STATE OF NORTH CAROLINA
DEPARTMENT OF TRANSPORTATION

June 17, 2015

RE: Addendum to the Sections 404 and 10 Individual Permit & Section 401 Water Quality Certification for the replacement of Bridges No. 12, 18 & 42 on NC 11 Over Cape Fear River and Overflow; Federal Aid Project No. BRSTP-0011(9) W.B.S. No. 33395.2.2 T.I.P. Project No. B-4028

Revised 6/9/2015
 Permit Drawing
 Sheet 15 of 19

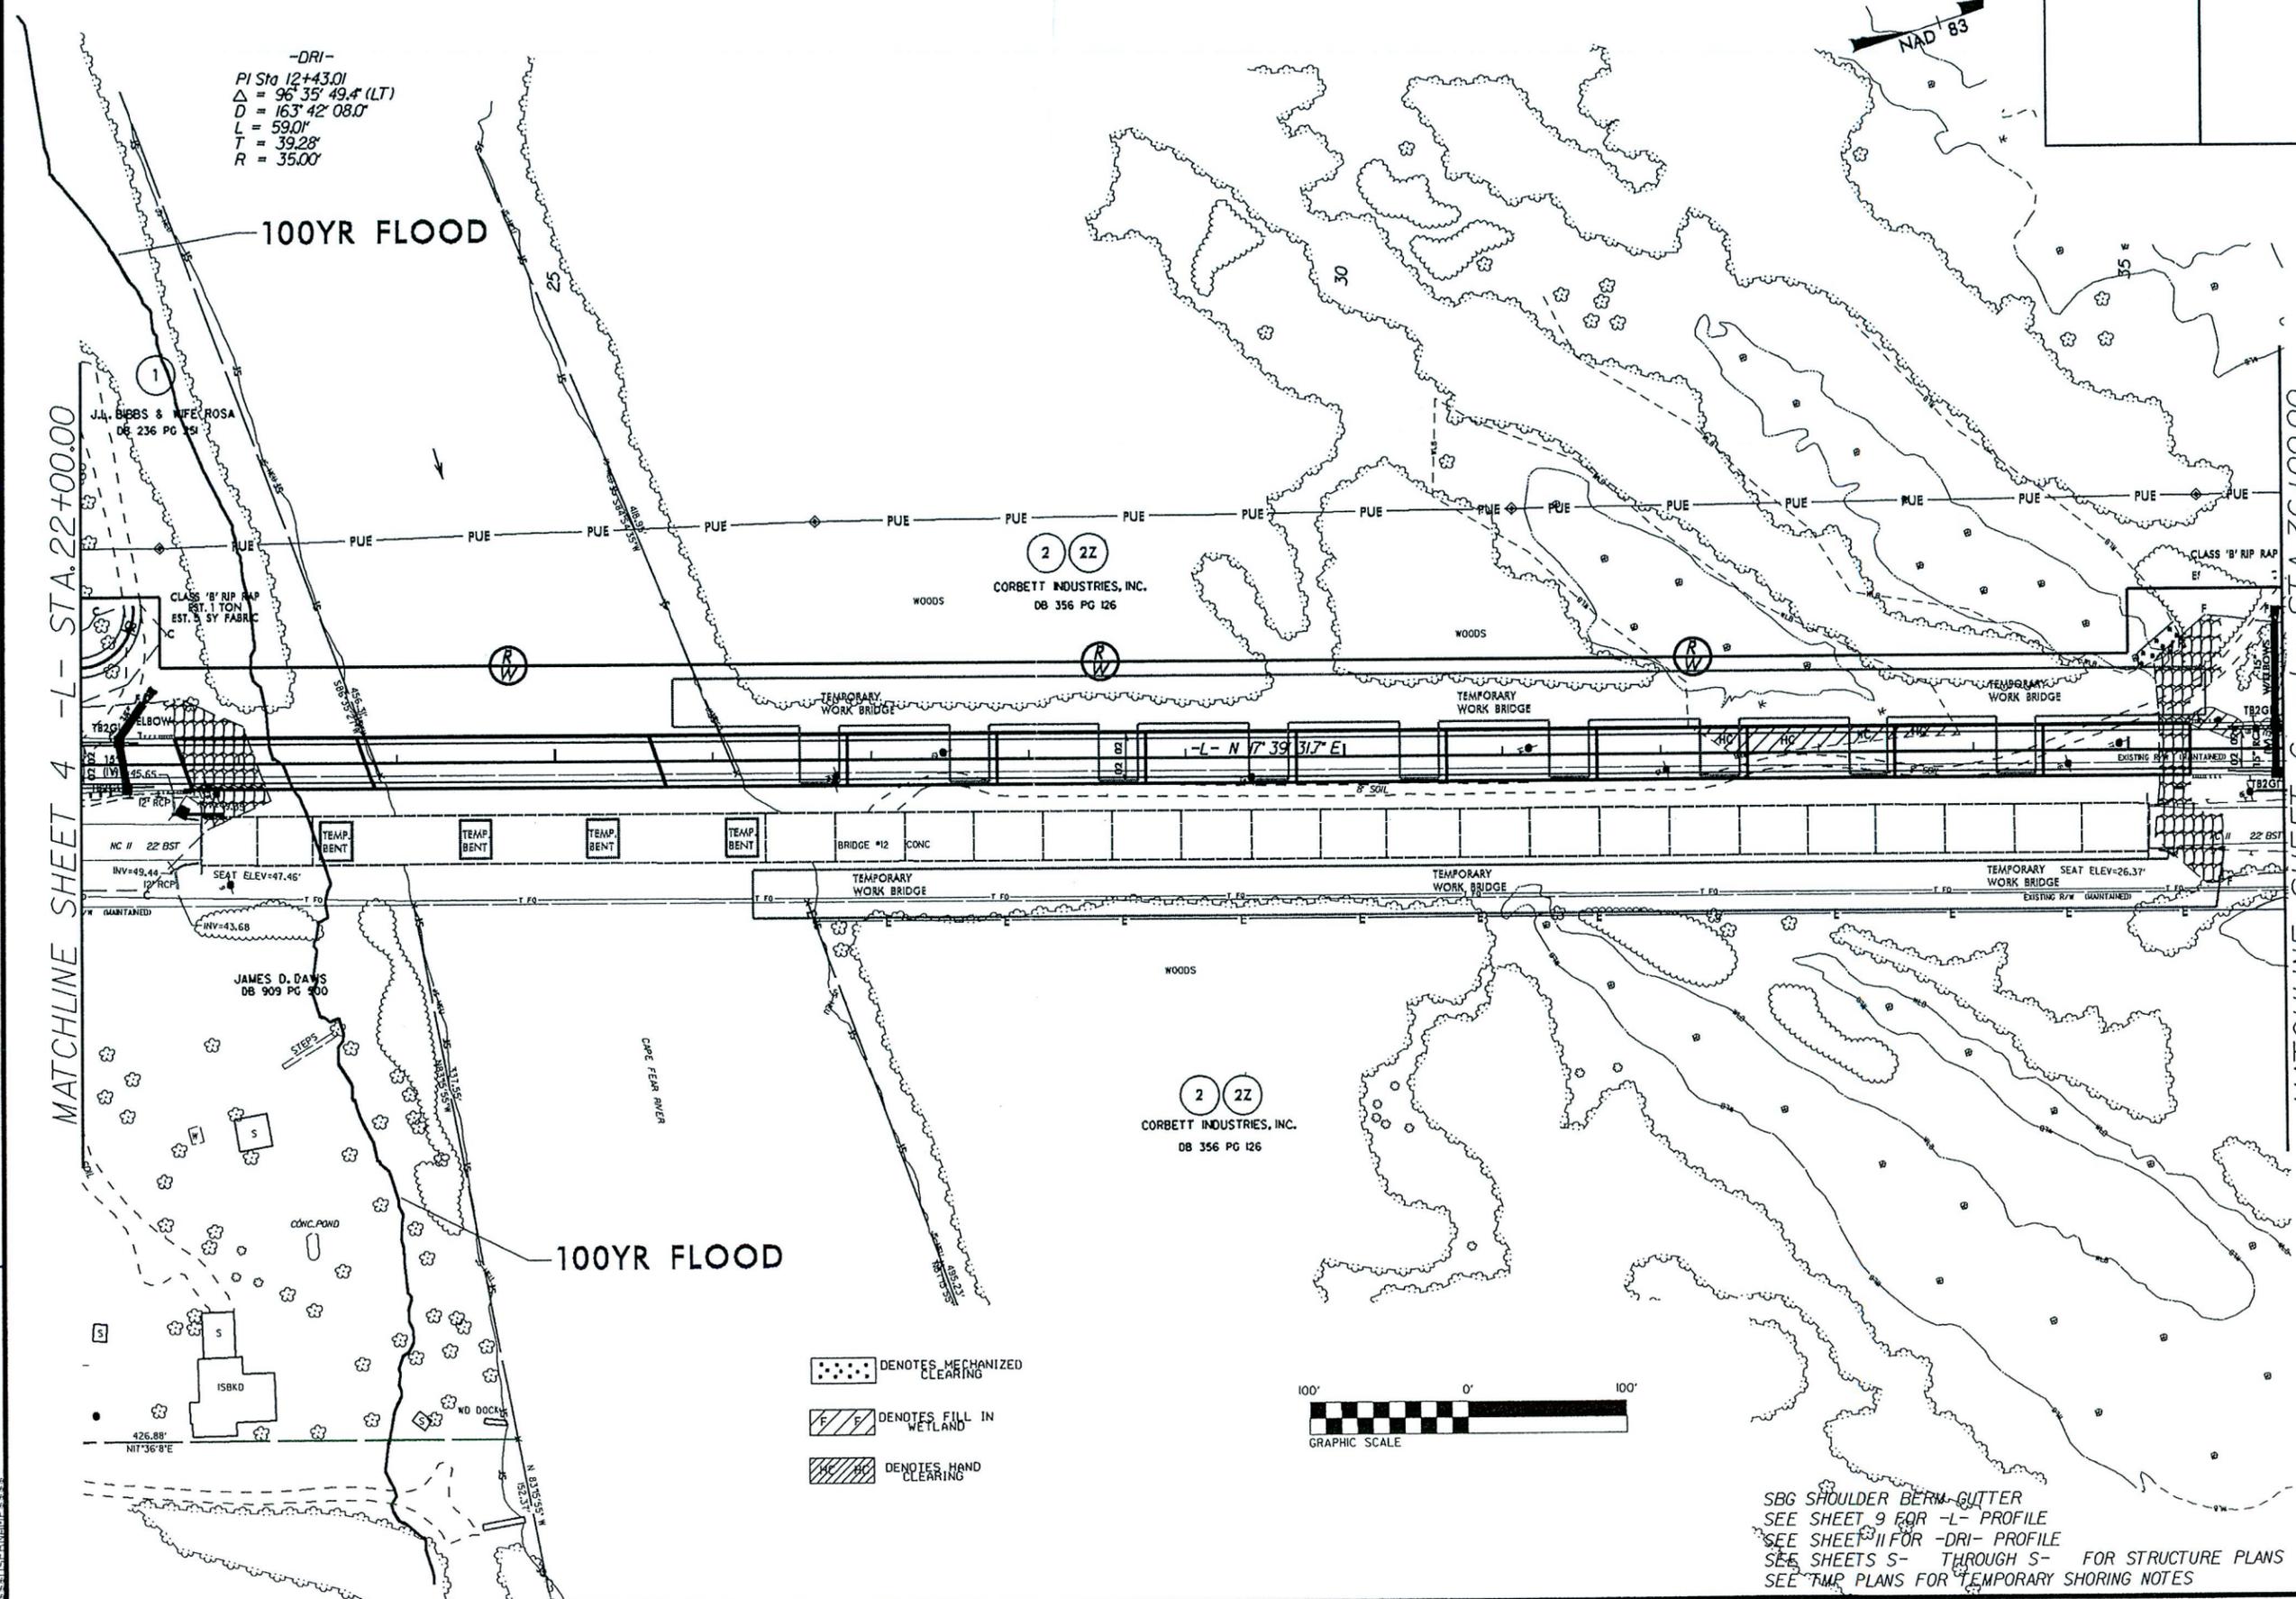
Please see the enclosed revised plan and profile view for the subject project. A discrepancy between the permit commitments and the construction plans necessitated clarification. The permit application stated that the existing causeway would be removed and the area graded down to natural ground elevation within the easement (pg. 7 of cover letter), however the Roadway plans submitted with the application (Cross section X-22) shows only partial removal. After confirmation with the contractor, the Department plans to grade the area in accordance with the Roadway plans.
